STATE OF HAWAII DEPARTMENT OF TRANSPORTATION HIGHWAYS DIVISION MECHANICALLY STABILIZED EARTH RETAINING WALL (MSERW) TYPICAL SECTION AND DETAILS KAHKILI HIGHWAY WIDENING Likelike Hwy. to Vicinity of Haiku Road F.A. PROJECT NO. NH-083-1(26) SCALE: AS NOTED DATE: APRIL 1994 SHEET No. W1 OF W21 SHEETS	
--	--

AS-BUILT ADD. 114

KAHEKILI HIGHWAY WIDENING
Likelike Hwy. to Vicinity of Haiku Road
F.A. PROJECT NO. NH-083-1(26)

PLAN AND PROFILE
R. C. WALL NO 14 AND 15
KAHEKILI HIGHWAY WIDENING
Likelike Hwy. to Vicinity of Haiku Road
F.A. PROJECT NO. NH-083-1(26)
SCALE: AS NOTED DATE: APRIL 1994
SHEET No. W17 OF W21 SHEETS

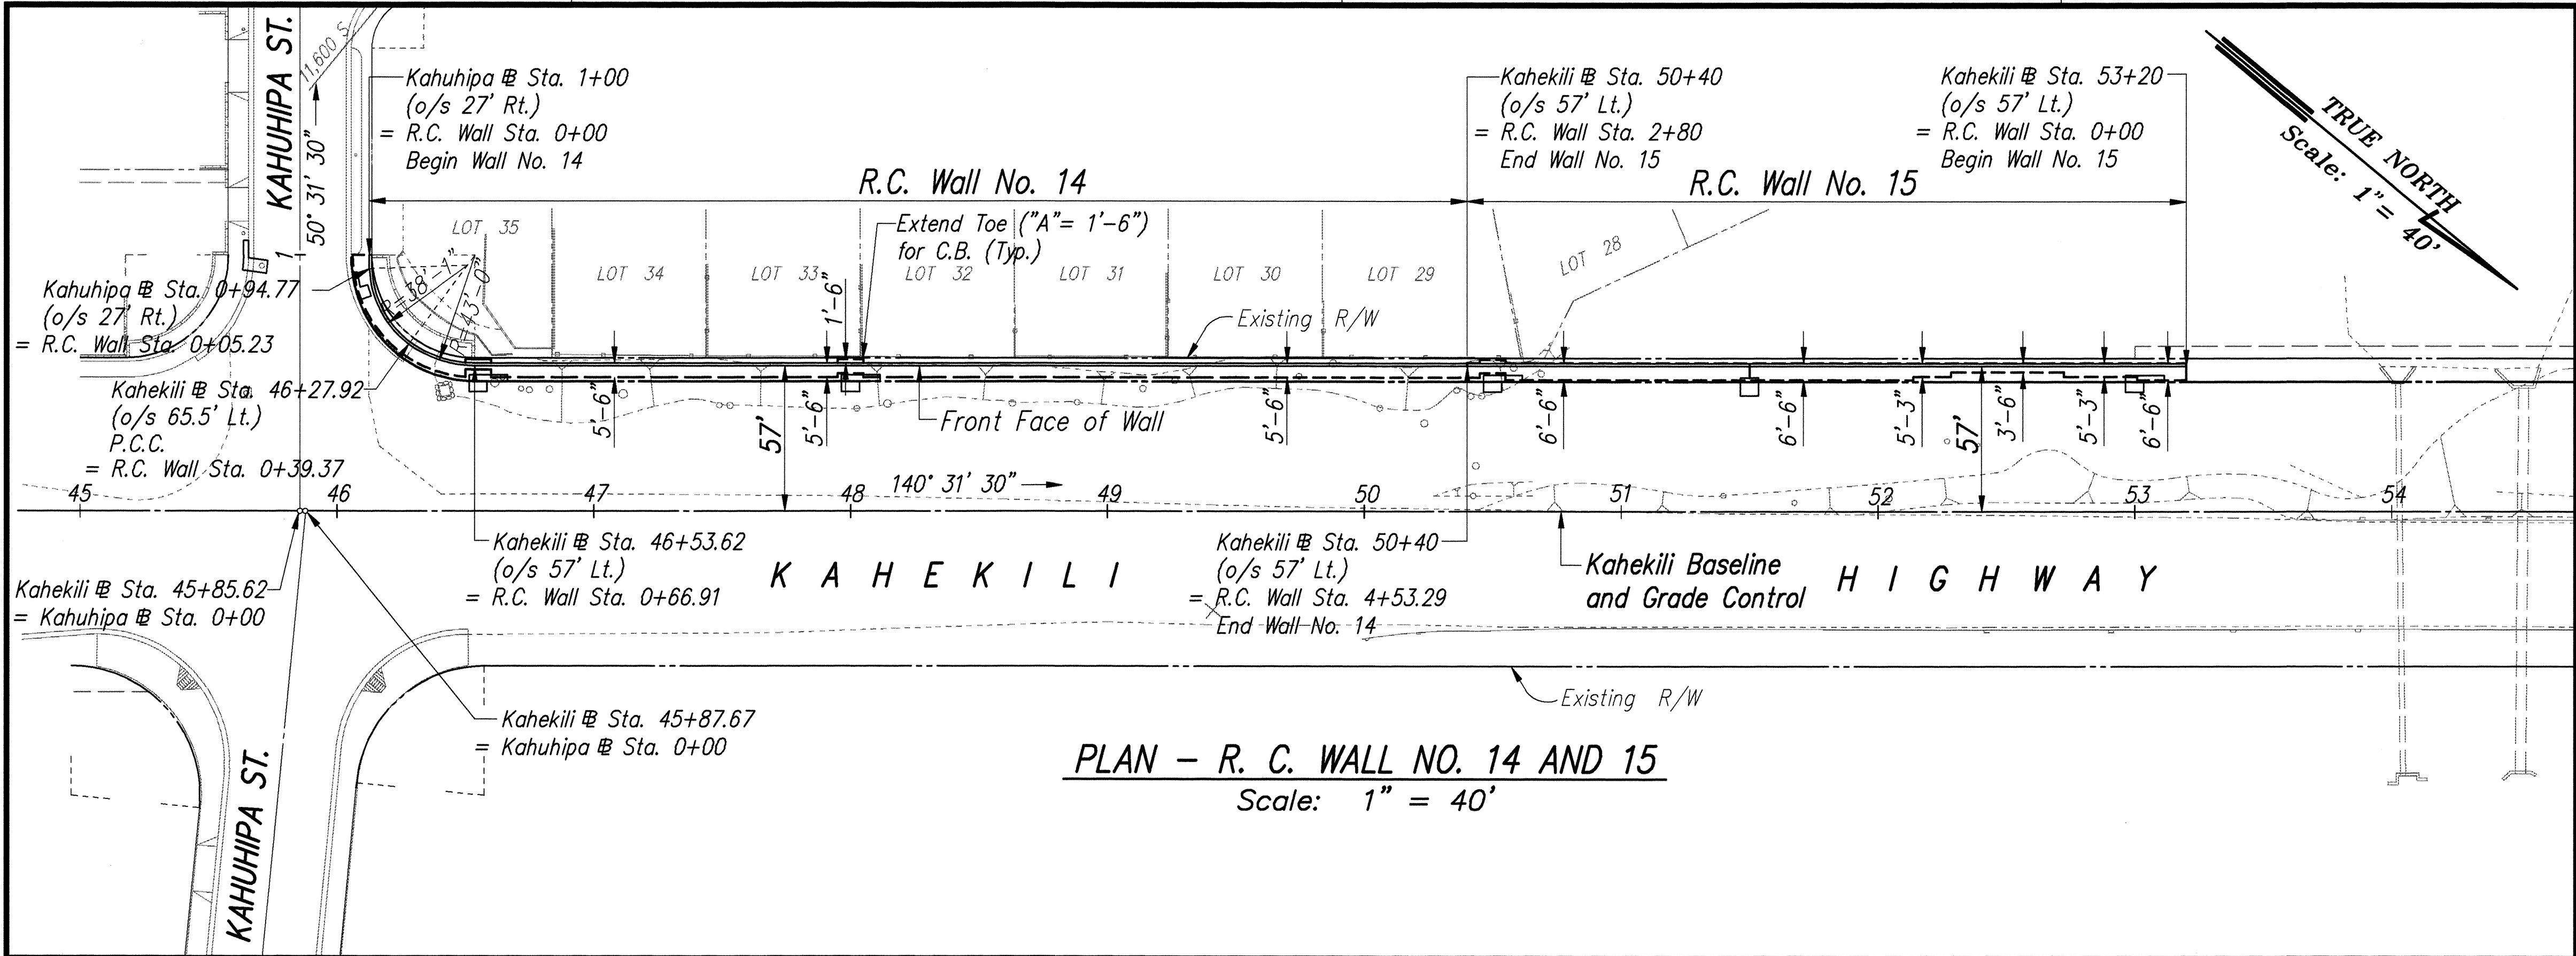
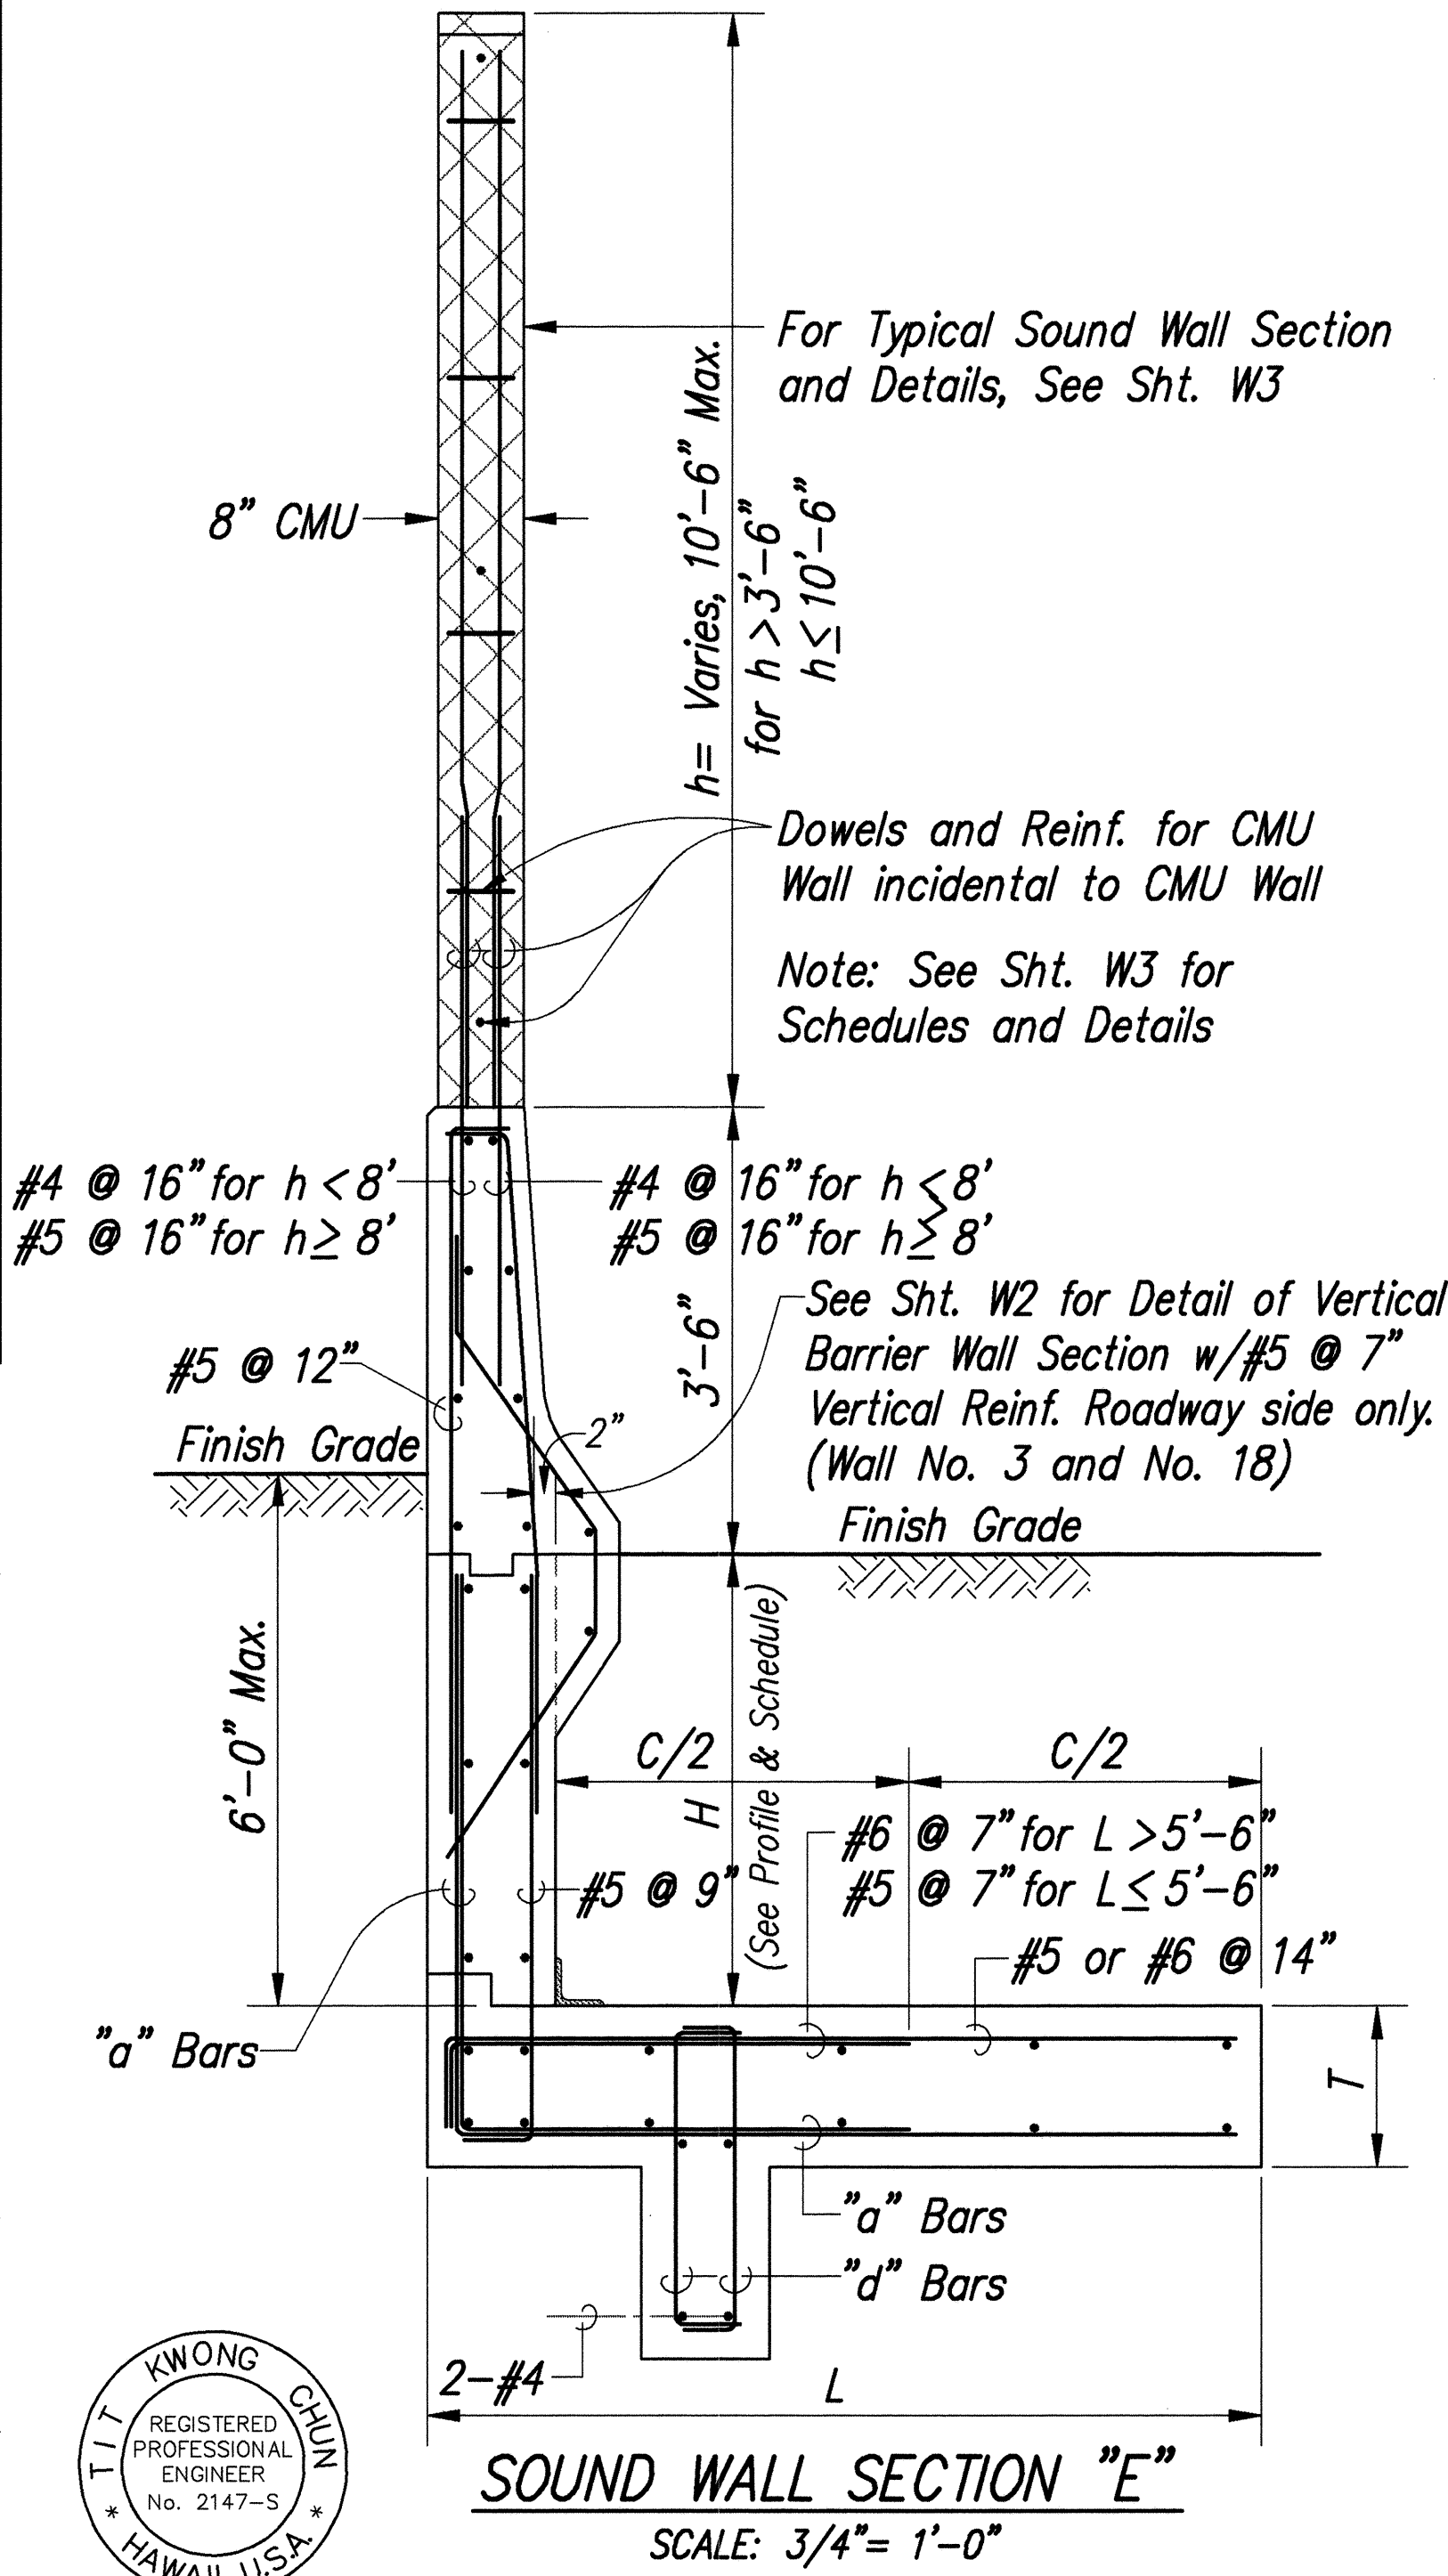
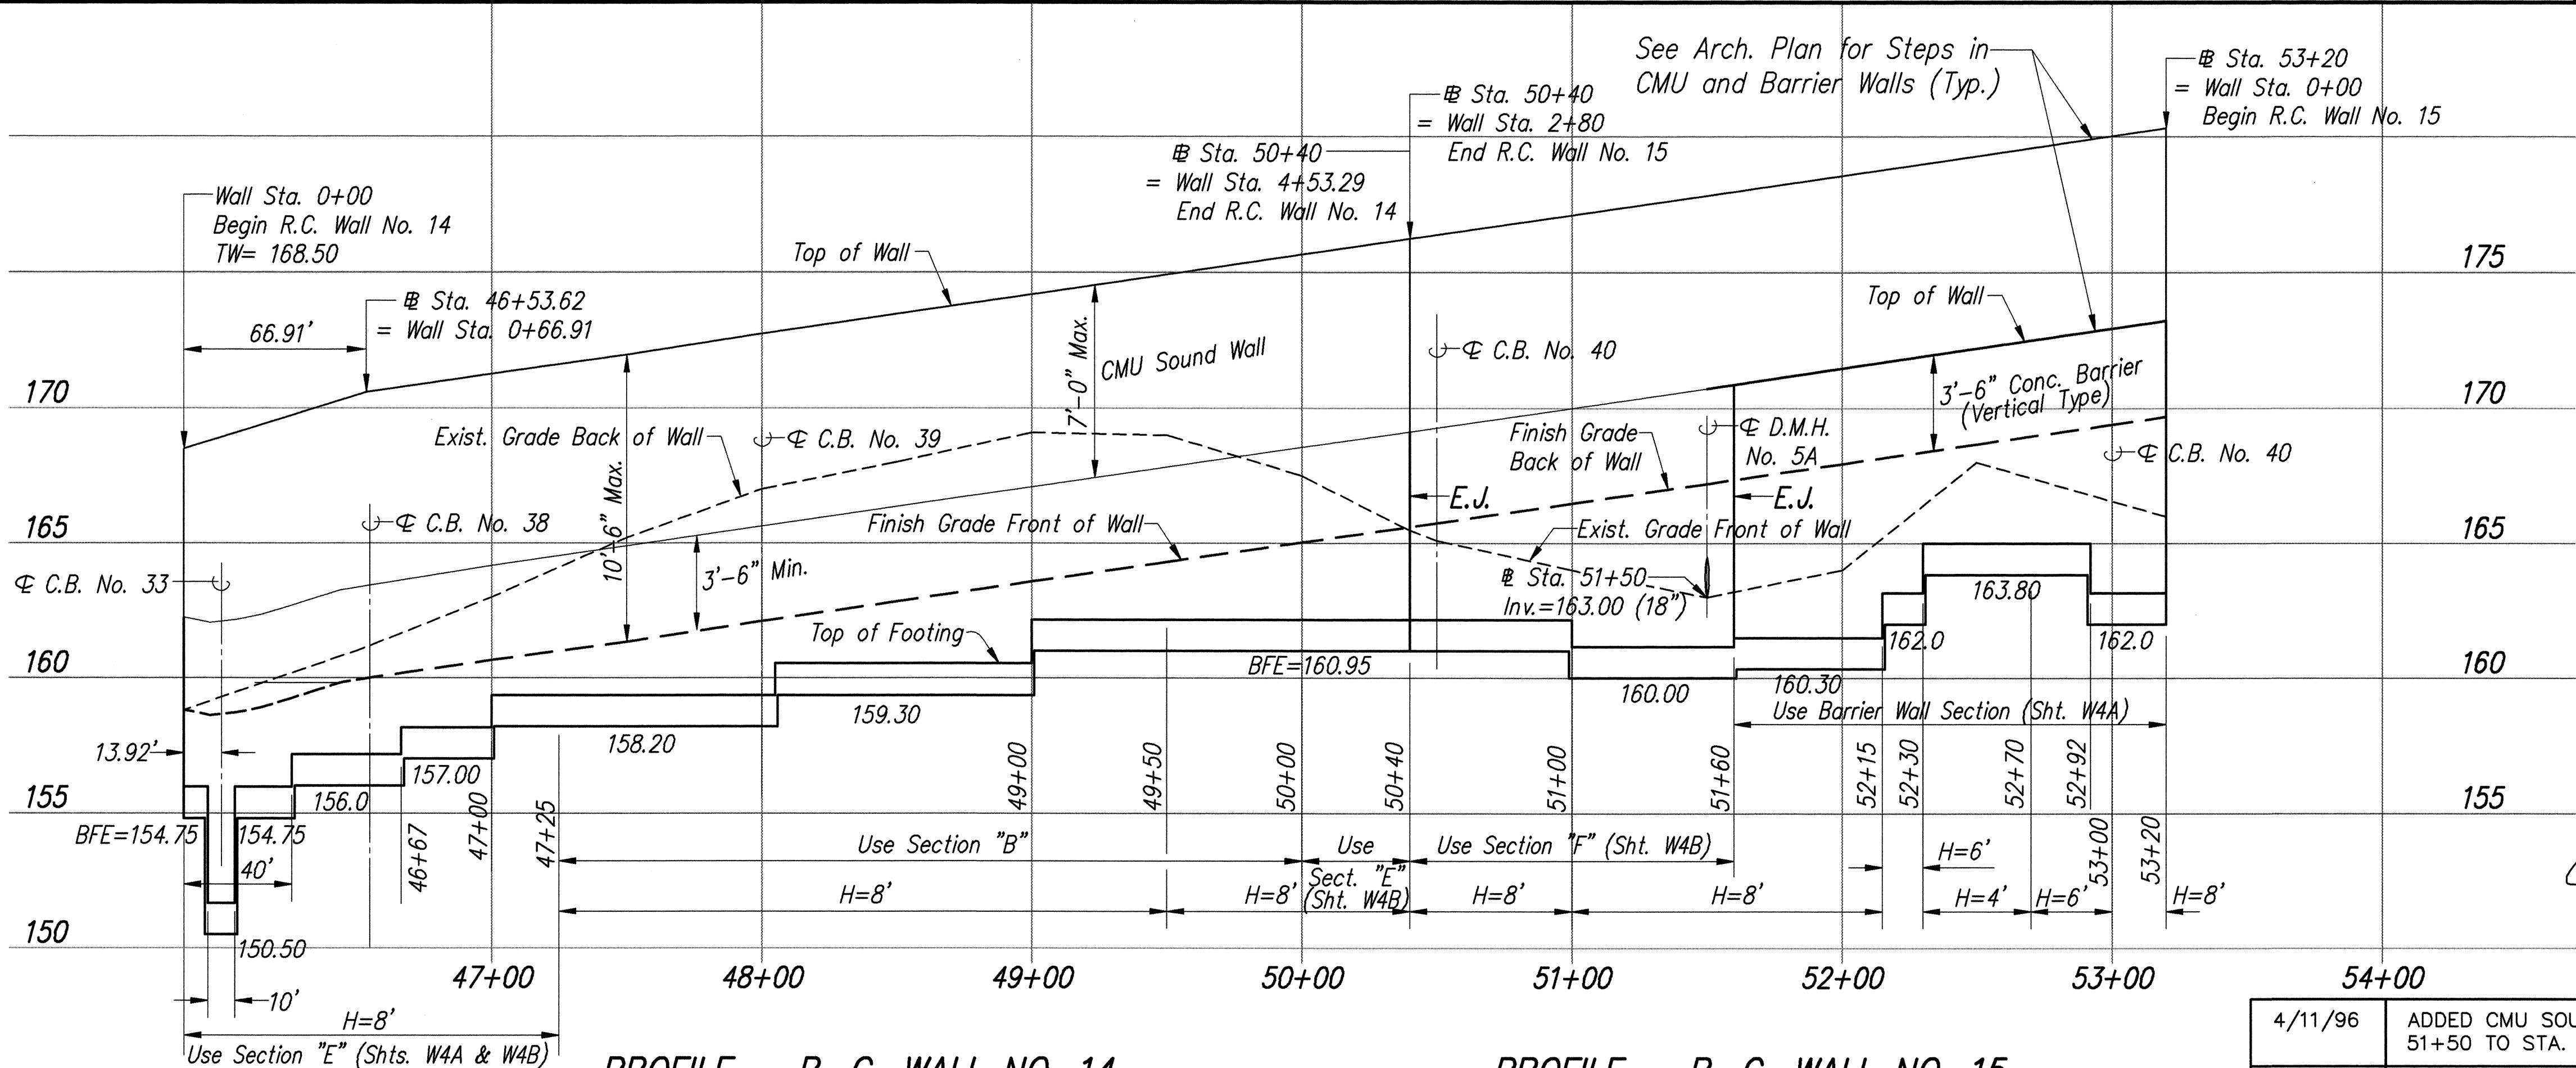
DATE	REVISION
4/11/96	ADDED CMU SOUND WALL FROM STA. 51+50 TO STA. 53+20 (LEFT)
12/05/95	REVISED WALLS TO VERTICAL TYPE.
6/07/94	REVISED WALL PROFILES, FOOTINGS AND WALL SECTION DETAIL.
